**ADDENDUM NO. 1  
TO THE CONTRACT DOCUMENTS**

**City of Lakewood  
Lakewood, California  
PW 2025-04**

**Drilling, Construction, Development, and Testing of Well 22B and Demolition of Well 22A**

# Water Well Supply, Inc. Well & Pump Data

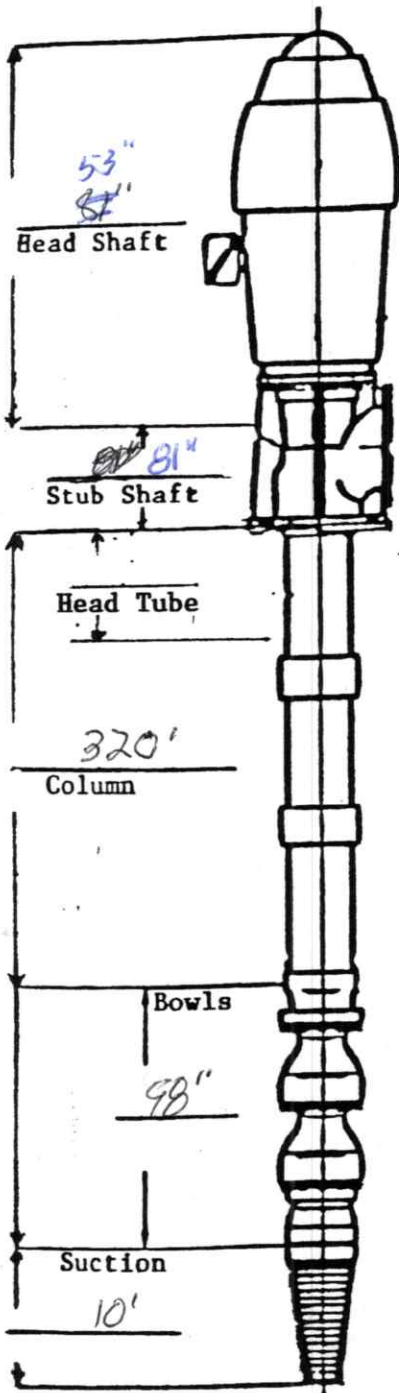
4. **Question:** Please provide column tube and shaft dimensions for pump in existing well.

5. **Question:** Please provide depth of pump.

27. **Question:** What is the size and depth of the pump in the well?

**Answer:** See attached pump details.

**Answer:** See attached pump details.

**Answer:** See attached pump details.

TITLE: WELL 22  
WELL LINER DESIGN

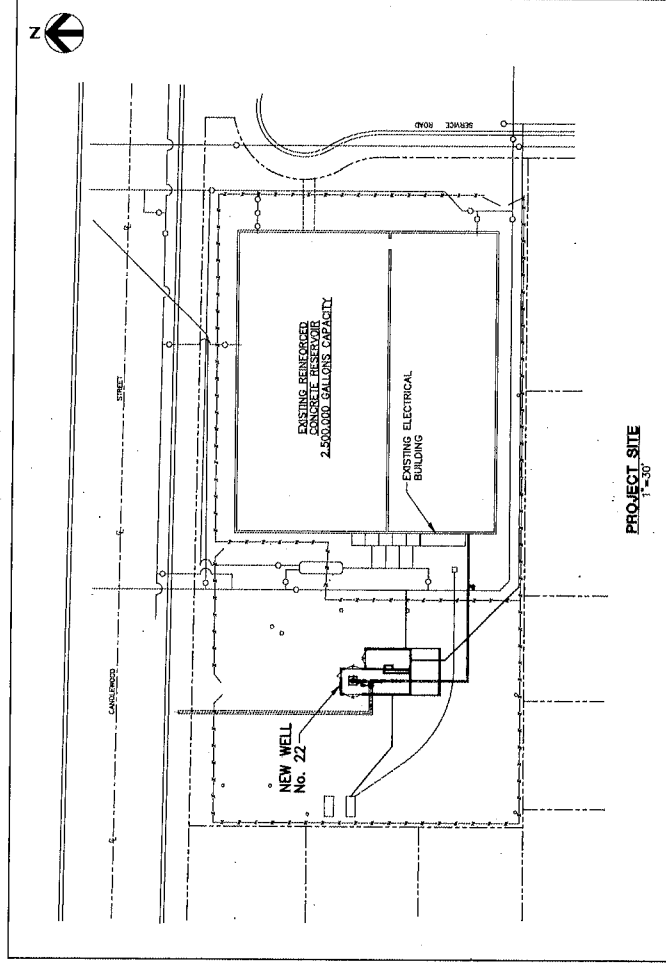
23. **Question:** Is there a State Well Completion Report for the liner installation in well 22?

**Answer:** No there is not a State Well Completion Report for Well 22A; however, a diagram has been included as an attachment.
